Government of India
Ministry of Railways
Research, Designs & Standards Organisation
Manak Nagar, Lucknow - 226 011

MODIFICATION SHEET NO. RDSO/WAM4/209

**REPLACEMENT OF THE EXISTING LATCHING TYPE OF FIXING
ARRANGEMENT WITH BOLTED DESIGN OF CRADLE COVER ON
VACUUM CIRCUIT BREAKER TYPE 20CB**

BOLTED DESIGN OF CRADLE COVER FOR VCB			FIRST ISSUED
			SUPERSEDES
RDSO.ELEC.DTE		SKEL-4472	SUPERSEDED BY

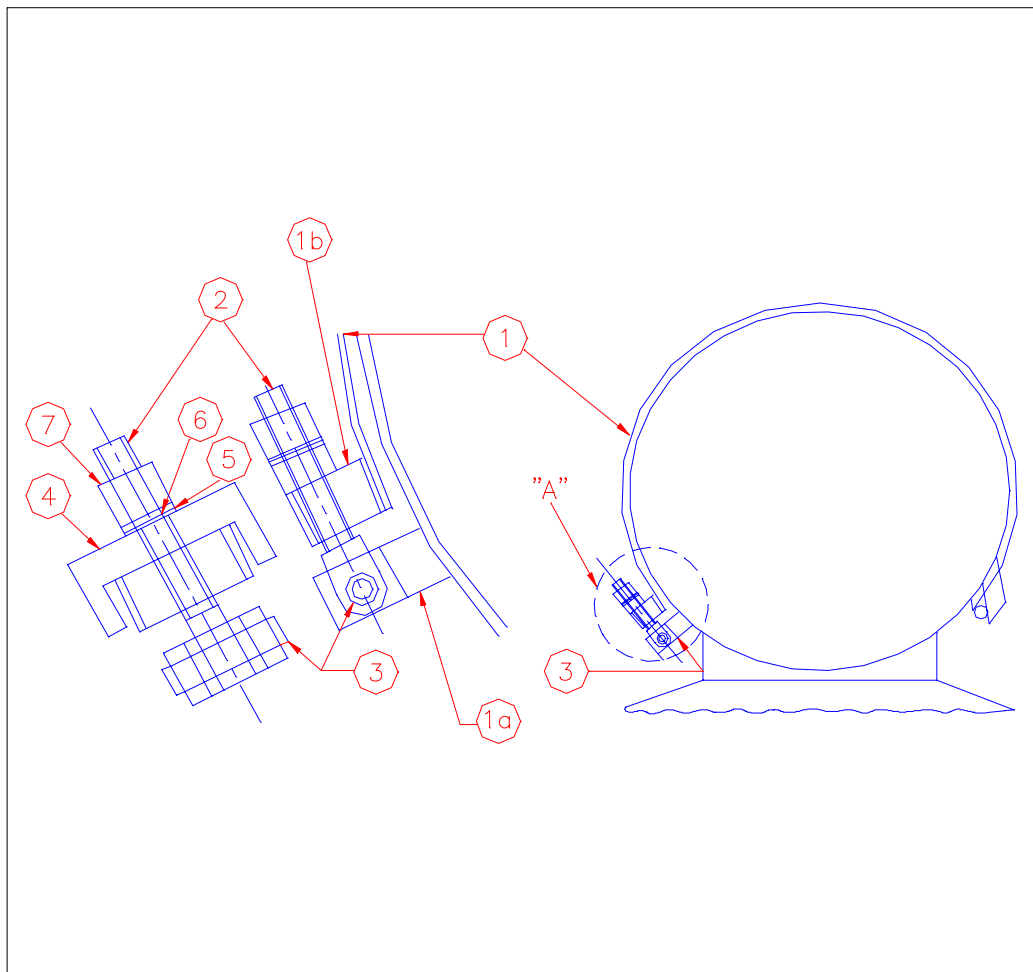
1.1 ways have reported number of cases of water entry from cradle cover resulting in have y flashover on the live parts enclosed. During investigation, it is observed that the water entry from cradle cover is mainly due to the following reasons:-

- i) Breakage of catch spring
- ii) Breakage of catch clamp
- iii) age of catch clamp and welding
- iv) Improper sealing of cradle cover

1.2 In order to overcome the problem of water entry from cradle cover, it is proposed to:-

- Modify the existing latching arrangement to bolted type of cradle cover.
- Increase the thickness of the rubber gasket in the cradle cover from 3 mm to 6 mm.

- Open the clip, remove the remove the existing cradle cover (Pt.1) and modify the same as per new design (Ref, SKEL-4472) enclosed.
- Remove the toggle spring and clip assembly from cradle by cutting tubular rivet from the confer.
- Place the eye bolts (Pt.2) between the catch brackets (Pt.2a) on cradle and fix them by passing one number rivet (Pt.3) through holes in catch brackets and eye bolts.
- Rivet both ends of the rivet (Pt.3).

- Fit the cradle cover (Pt. 1) such that the threaded portion of eye bolts pass through the catch (Pt. 1b)
- Pass the support brackets (Pt.4) through the eye belts (Pt. 2) such that they rest on catch (s) (Pt. 1b)
- Lock the arrangement using M6 plain washer (Pt. 5) M6 single coil spring washer (Pt. 6) and M6 Hexagonal nut (Pt. 7)
- Finally seal the cradle cover in line with RDSO SMI No. 161 (Rev. I)
